From: Mitman, Jeffrey | NRC
Sent: Monday, December 20, 2010 2:41 PM
To: Ferrante, Fernando | NRC
Subject: FW: Spillway Curve
Attachments: Hydralogy - N values and Spillway Curves.pdf

Spillway Discharge Curve

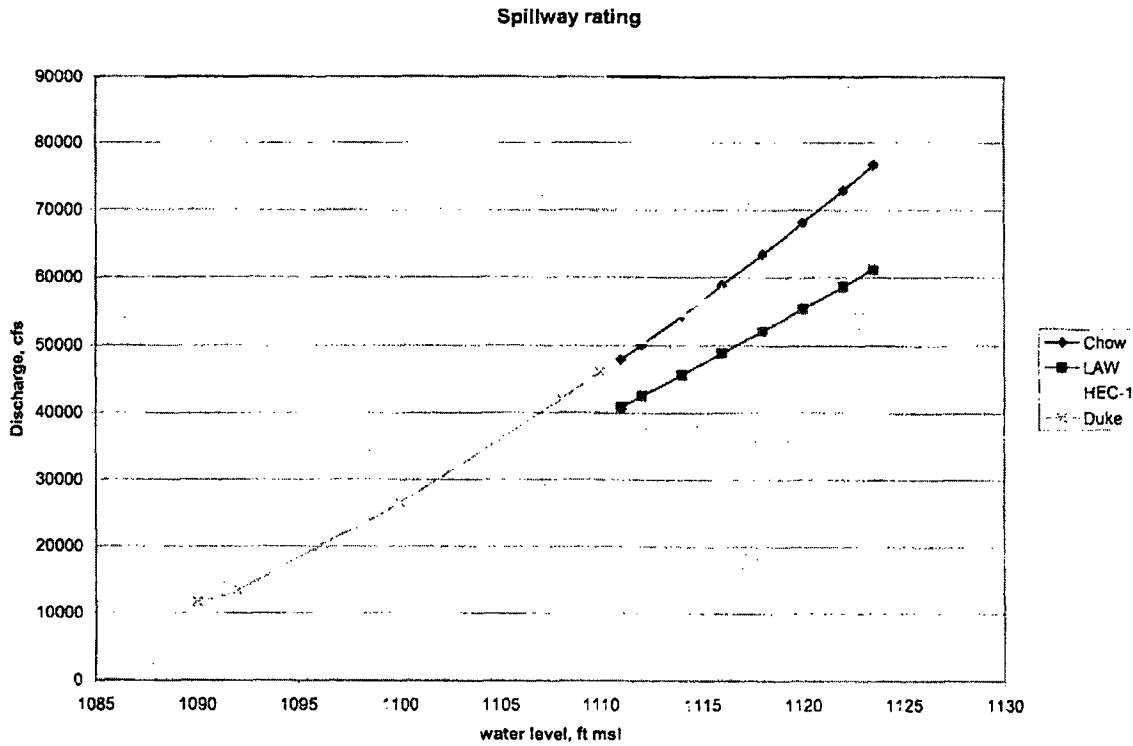
The spillway discharge curve as used in the LAW Engineering analysis could not be confirmed in this evaluation. The staff did calculate a spillway rating curve using information developed by the U.S Army Waterways Experiment Station and presented in Section 14.7 of Open Channel Hydraulics (Chow, 1959). In this method, piers in gated spillways are adjusted for using the relationship $L = L_0 - K N H_e$ where:

With the spillway coefficient of discharge equal to 4.0, $Q = 120 H_e^{1.5}$ for each bay of the spillway. This relationship corresponds approximately to the discharge curve by Duke used by FEI in the FERC report (2004) presented in this report. The discharge determined in the original study evaluated by AEC approximates the value that would be determined from this relationship (72,000 cfs as compared to 73,660 cfs).

The staff also considered the methodology presented in the HEC-1 program manual. Using this methodology, a different shaped curve was determined. Also, the original rating curve ended at

el 1123.5 because the low chord of the bridge is at this elevation and flow out of the reservoir changes to orifice flow at this level. Because of the higher water levels to be evaluated, the rating curve was adjusted for orifice flow and added to the program. All three rating curves are shown in Figure ____.
